## CITY OF ST. HELENS PLANNING DEPARTMENT

# LAND USE FILE BRIEF

TO: Planning Commission  
FROM: Jacob A. Graichen, AICP, City Planner  
FILE: Variance V.4.23 & Minor Modification Site Development Review SDRm.3.23  
DATE: May 1, 2023

## Variance V.4.23 & Minor Modification Site Development Review SDRm.3.23

Excerpt of approved site plan with notes by staff explaining as-built discrepancies. Note the blue 1, 2 and 3 when looking at the pages that follow.

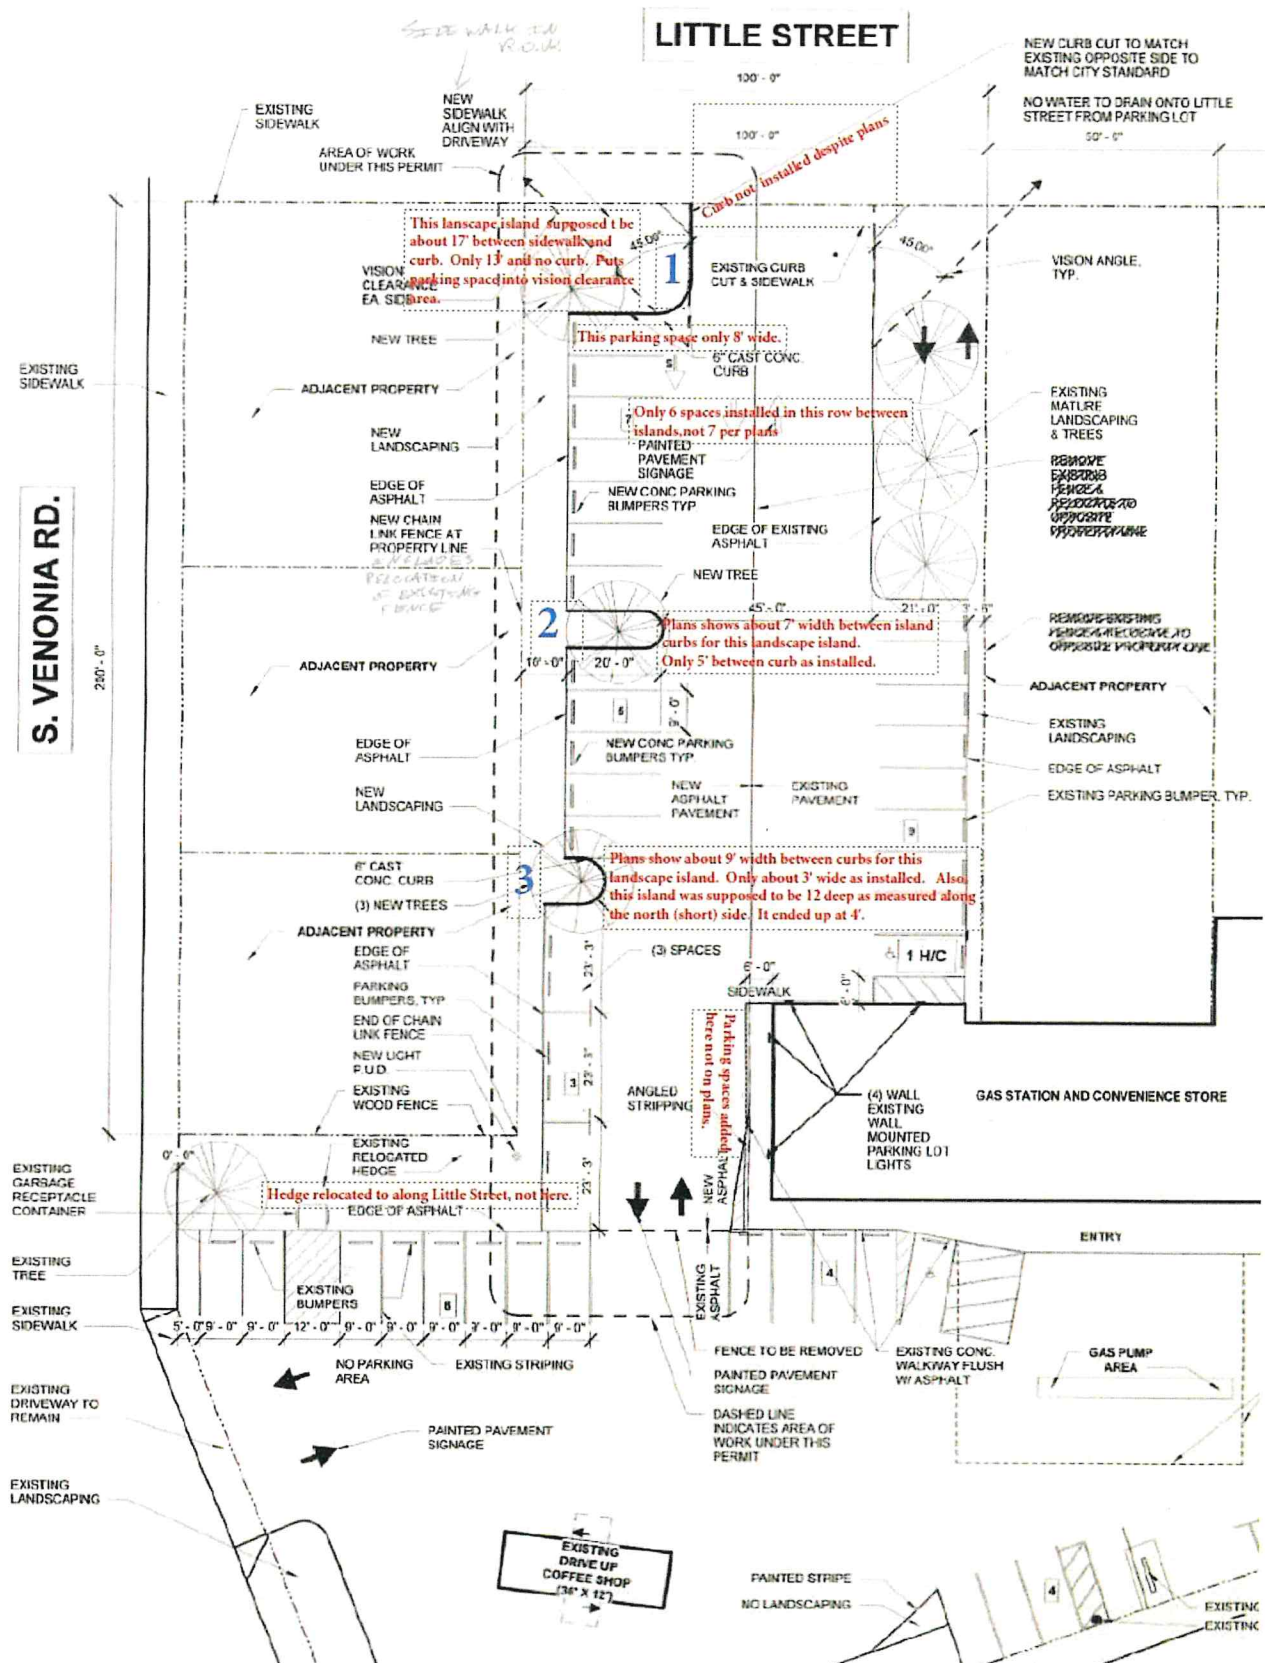
Approved plans had this area at 17' between the sidewalk and curb. It also showed a curb on the opposite side of the sidewalk. It was only constructed with an approximate 13' length between the back of sidewalk and parking stall. No curb was installed. In addition, a street tree was installed with a dba of much less than the normal 2" minimum.

Approved plans showed an island width between curbs of 7 feet. It was constructed at 5' between the curbs. The minimum width is 6' between curbs. Being slightly off from the minimum and having a tree that more closely honored the 2" caliper identified on the approved plans, this is the least problematic of the three islands and is a fair representation of a typical landscape island not along a street.

Approved plans showed an island width between curbs of 9' and a depth of 12' as measured from the landscape edge on the right side as seen in this photo (i.e., the short edge). Instead of the 9' x 12' dimension of the approved plan, this island was installed as 3' x 4' including the curb.

This is far less than the minimum 6' dimension exclusive of curbs and the landscape island tree, far below the 2" caliper per the approved plans, was planted behind the island due to

insufficient space. Though curb was installed, this may be the most egregious of the changes compared to the approved plan.

- Approve as is with reduced area, no curb and insufficient street tree
- Consider approval but the curb to be installed and street tree of the proper size
- The adjacent parking space needs to be designated compact or eliminated by non-parking markings such as diagonal lines or increasing the landscape island size

- Approve as is with reduced area.
- If denied will need to be reconstructed which will impact 1 or 2 parking spaces.

- Approve as is with reduced area and insufficient tree.
- If denied will need to be reconstructed which will impact 1 or several parking spaces—see next bullet point.
- Note that the parallel parking spaces to the left of this island are oversized as the minimum length of such space is 22 feet. The applicant identifies the as-built dimension as 25 feet. With three spaces, this is an extra 9 feet, which is what the proposed landscape island width was supposed to be.
